HISTORIC AND DESIGN REVIEW COMMISSION

January 19, 2022

HDRC CASE NO: 2022-014
ADDRESS: 207 ROOSEVELT AVE
LEGAL DESCRIPTION: NCB A20 BLK LOT 6,7, 8 & PT OF A22 OR ARB P EXC S IRR 183.25 FT OF W 117 FT & 5 (.539 AC) & N HALF OF A20(LOT 13)
ZONING: I-1, H, RIO-4
CITY COUNCIL DIST.: 5
DISTRICT: Mission Historic District
APPLICANT: Mo Verdecanna/Alamo Architects
OWNER: Joe Bakke/KENEDY JUNCTION LTD
TYPE OF WORK: Construction of a commercial structure, site work, construction of a parking lot, exterior modifications to the 2-story historic structure, roof replacement on the 2-story historic structure, modifications to the 1-story mausoleum structure, construction of an accessory structure, entrance elements, exterior modifications
APPLICATION RECEIVED: December 30, 2021
60-DAY REVIEW: Not applicable due to City Council Emergency Orders
CASE MANAGER: Edward Hall
REQUEST:

South Roosevelt Development

Second Floor Plan

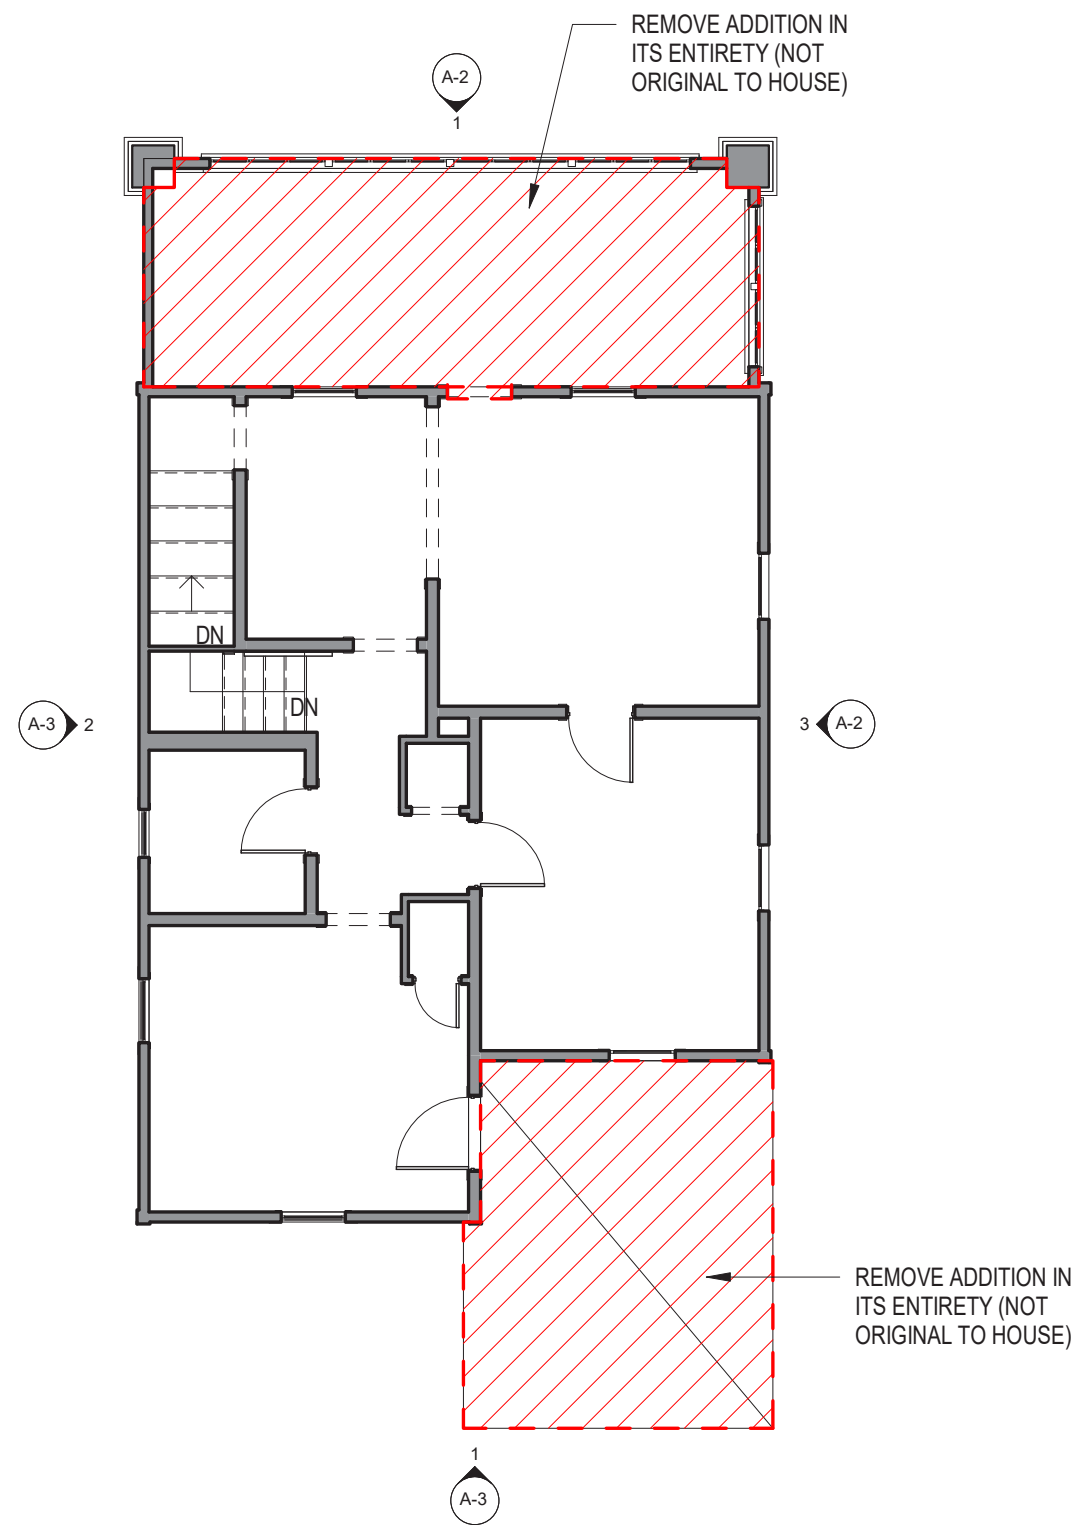
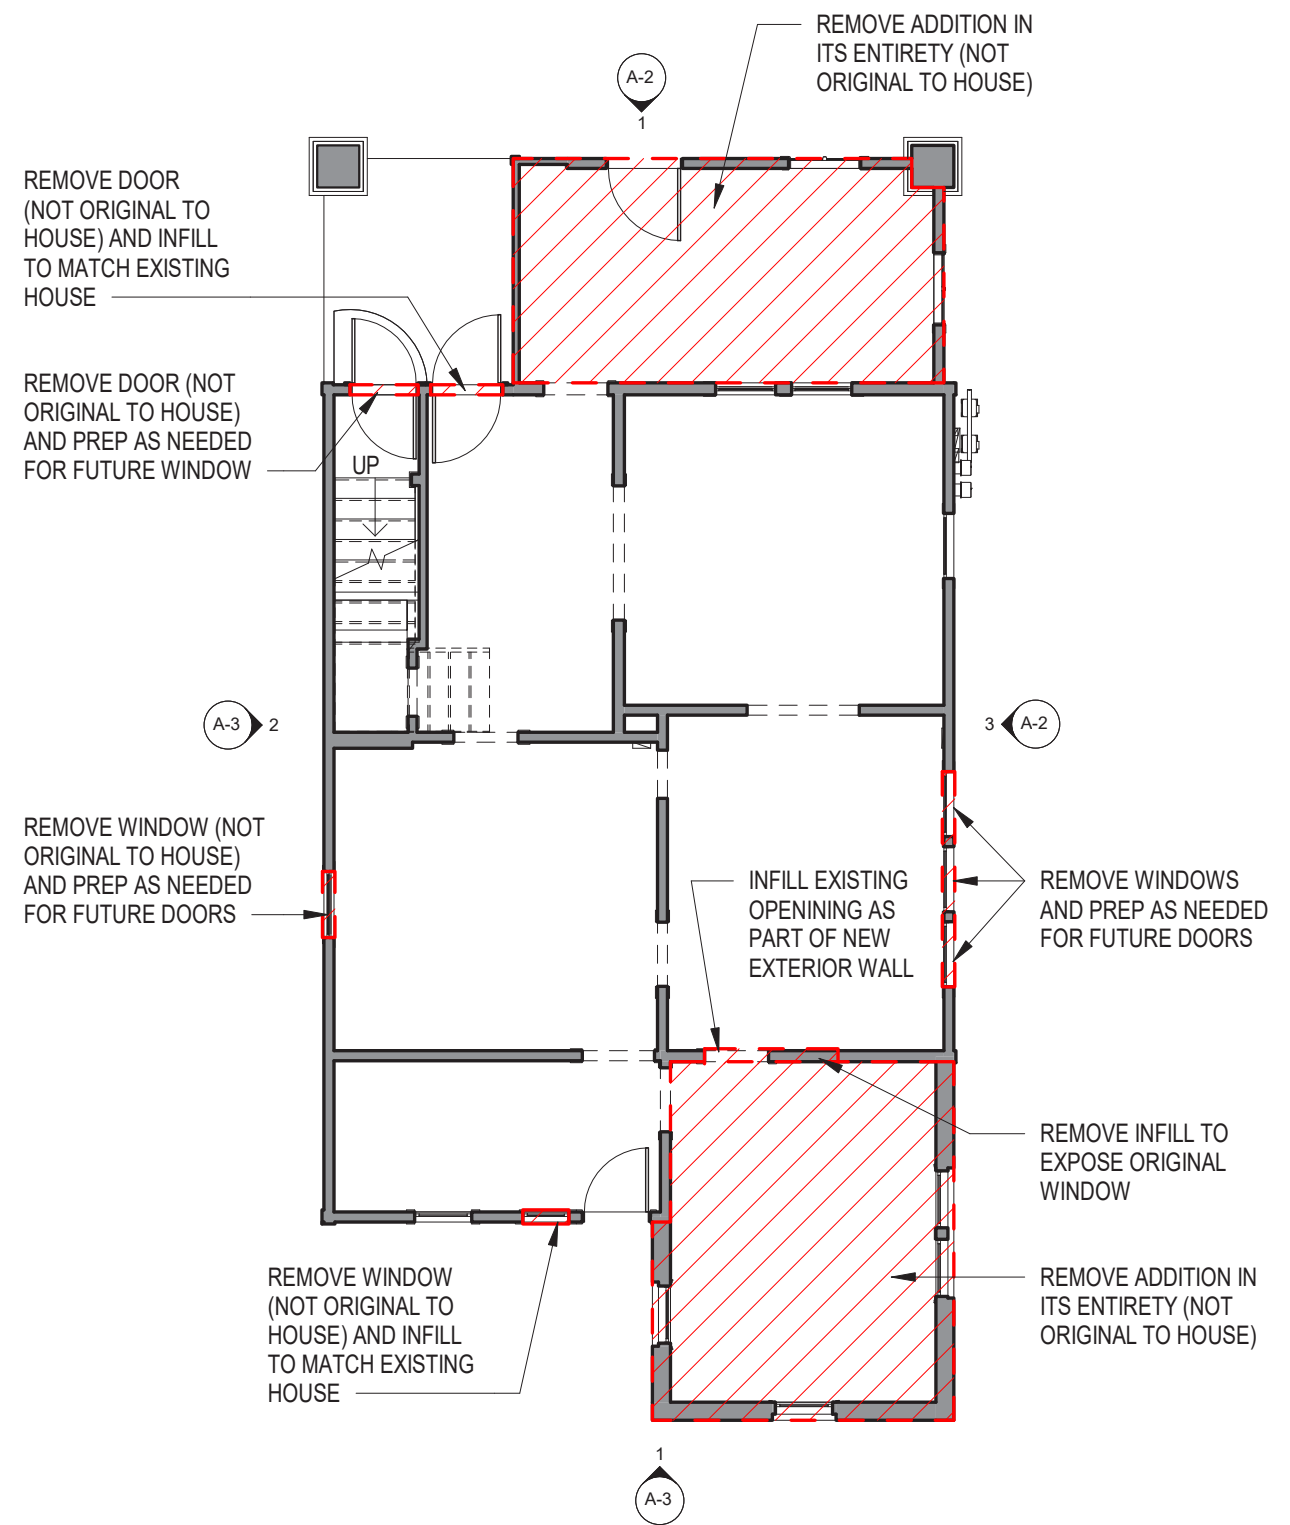
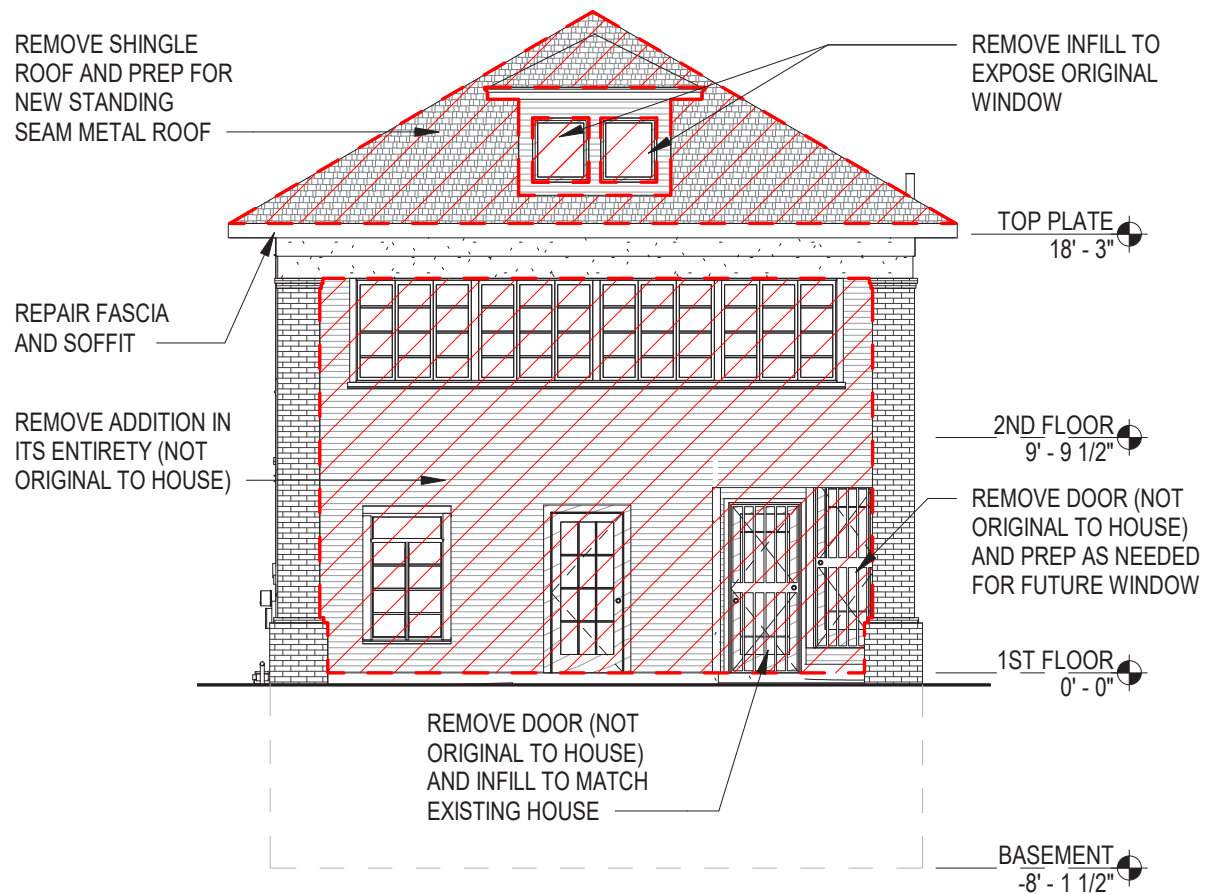
- f. **NEW CONSTRUCTION (Mass, Scale, and Form)** – The Mission Historic District Design Manual 2.B. notes that wall planes and fenestration should be organized to yield facades that appear monolithic and enduring while still allowing for visual interest through breaks in scale and pattern, facades should not exceed more than fifty (50) feet in length uninterrupted, and heights should not exceed more than 3 stories in height. Generally, staff finds the proposed mass, scale, and form to be appropriate and consistent with the Mission Historic District Design Manual.

- g. **NEW CONSTRUCTION (Roof form)** – The Mission Historic District Design Manual 2.C. notes that a flat roof with a parapet wall is recommended as a primary roof form for all commercial buildings. Secondary roof forms such as gabled or hipped roofs are recommended when subordinate to the primary roof form. The existing, primary structures on site feature primary roof forms that are gabled and hipped. The applicant has proposed a gabled roof form. Given the existing context on site, staff finds the proposed roof form to be appropriate.

- h. **NEW CONSTRUCTION (Materials)** – The applicant has proposed materials that include stucco, metal façade panels and a metal roof. The Mission Historic District Design Manual 2.D. notes that primary facades should consist of materials that are vernacular to San Antonio, such as stone, wood and stucco and that seventy-five percent (75%) of the exterior facades should consist of these materials. Non-traditional materials may make up twenty-five percent (25%) of these facades. When stucco is applied, it should be done by hand and feature traditional finishes and control joints at locations where there is a change of material or wall plane. Generally, staff finds the proposed materials to be appropriate; however, stucco should be applied in a manner that is consistent with the Mission Historic District Design Manual.

- i. **WINDOWS** – The applicant has not noted window materials at this time. Staff finds that windows that match those previously used on site are appropriate. Additionally, the installation of a wood or aluminum clad wood window that is consistent with staff's standards for windows in new construction is also appropriate.

2. Staff recommends approval of item #2, the construction of a commercial structure based on findings d through j with the following stipulations:
 - i. That stucco is applied in a manner that is consistent with the Mission Historic District Design Manual, as noted in finding h.

- ii. That windows that match those previously used on site or wood or aluminum clad wood windows be installed that are consistent with staff's standards for windows in new construction, as noted in finding i.
